UNITED STATES PATENT AND TRADEMARK OFFICE

APPLICATION NO.	FILING DATE	FIRST NAMED INVENTOR	ATTORNEY DOCKET NO.	CONFIRMATION NO.
09/680,277	10/06/2000	Je Hong Kim	2658-0242P	8486

Office Action Summary

DETAILED ACTION

FIG. 4

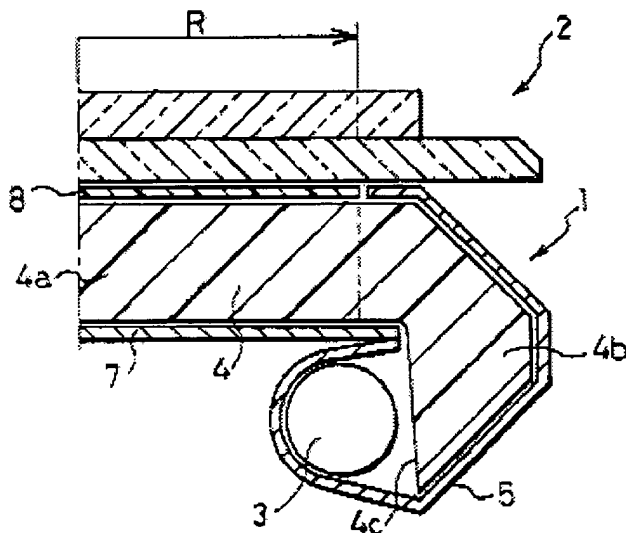
Oyama teaches in Figure 4 a light unit comprising a light-guide plate, 4a, and a reflector, 5, having a sectional view of spiral shape that efficiently guides the light (Applicant's high focus) from the light source to the light guide plate (col. 6, lines 13-24).

Oyama is evidence that ordinary workers in the art of liquid crystals would find the reason, suggestion, or motivation to add efficient reflection (high focus) to reduce bright lines in the display near the light source (col. 13, lines 33-52, especially lines 42-48).

Oyama teaches in Figure 4 a light-guide plate, 4a, installed at height different from the light, 3, input to reduce the outside dimensions of the entire apparatus with respect to the area of the display space (col. 2, lines 53-60) having a sectional view of spiral shape.

FIG.14(b)

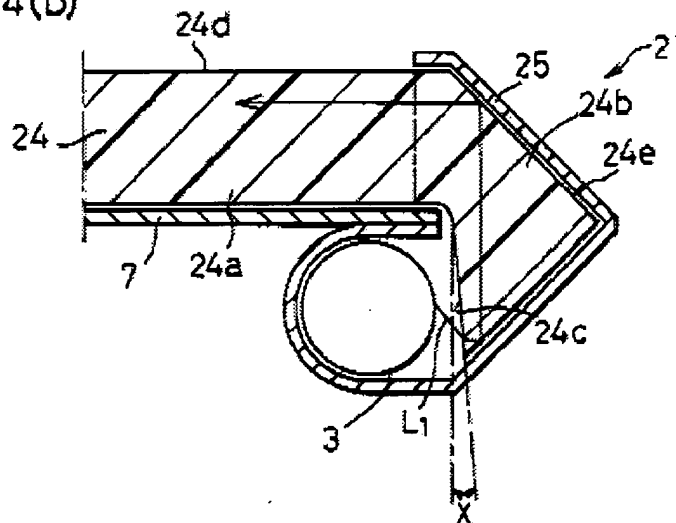
As to claim 5, Oyama teaches in Figure 14(b) a light unit wherein the reflective plate, 25, is curved to obtain a desired vertical incident angle of the light beam progressing to the light-guide plate to reduce bright lines in the display near the light source (col. 13, lines 33-52, especially lines 42-48).

Oyama is evidence that ordinary workers in the art of liquid crystals would find the reason, suggestion, or motivation to use a light unit wherein the reflective plate is curved to obtain a desired vertical incident angle of the light beam progressing to the light-guide plate to provide desired illumination characteristics.

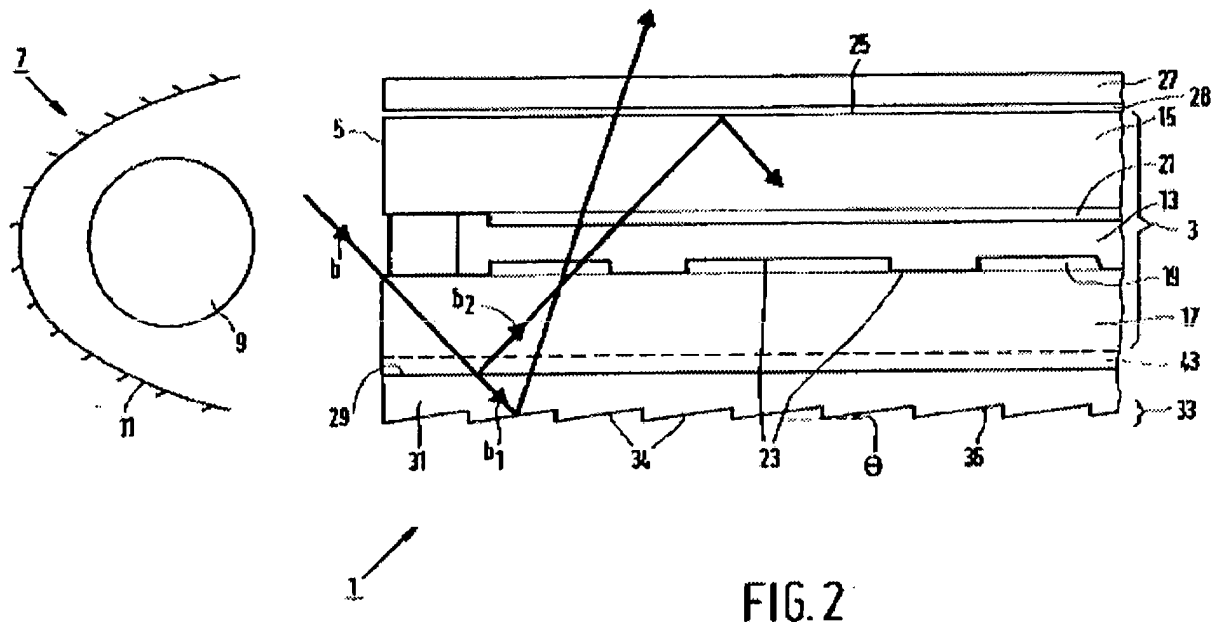
As to claim 7, Oyama teaches in Figure 14(a) a light unit wherein the lamp housing includes at least one reflective plate for cutting off the light beam progressing directly from the lamp into the light-guide plate, the at least one reflective plate being a protrusion of the inner surface of the lamp housing.

Oyama is evidence that ordinary workers in the art of liquid crystals would find the reason, suggestion, or motivation to use a reflective plate for cutting off the light beam progressing directly from the lamp into the light-guide plate, the at least one reflective plate being a protrusion of the inner surface of the lamp housing to provide desired illumination characteristics.

FIG. 7

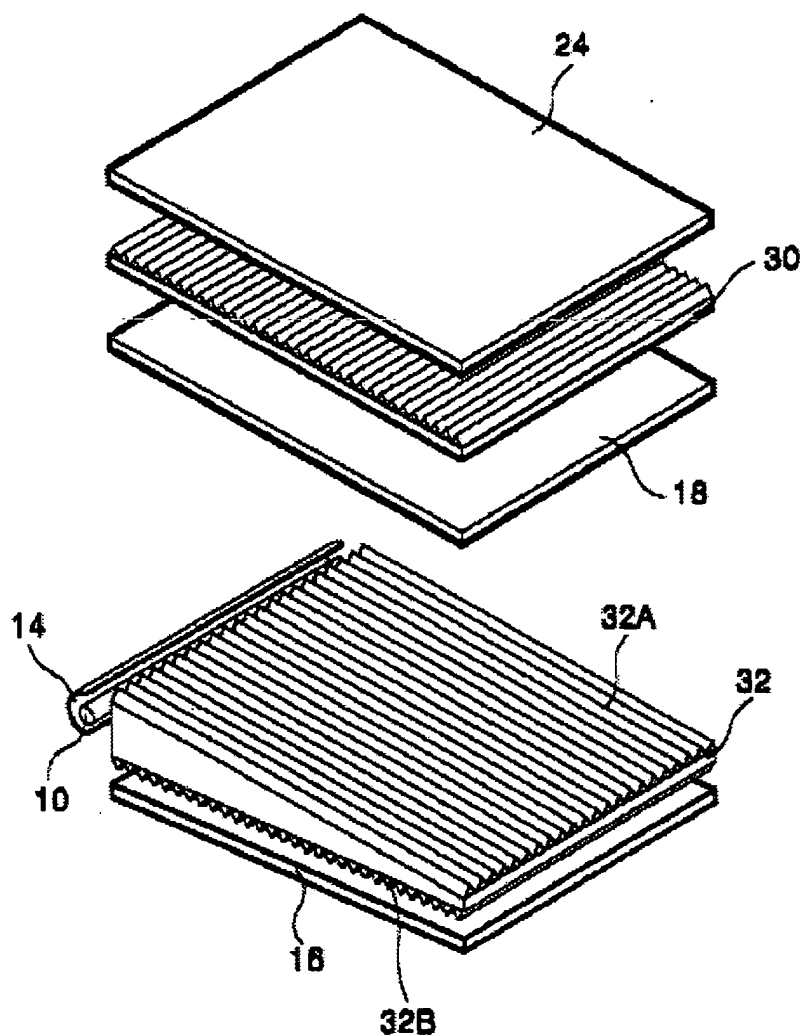
Kim teaches in Figure 7 the use of a light unit wherein the light-guide plate includes a plurality of prism patterns arranged on another surface thereof in intersection with the unit patterns.

Kim is evidence that ordinary workers in the art of liquid crystals would find the reason, suggestion, or motivation to add a plurality of prism patterns arranged on another surface thereof in intersection with the unit patterns to enhance the utilization ratio of the light generated by the lamp (col. 6, line 58 through col. 7, line 15).
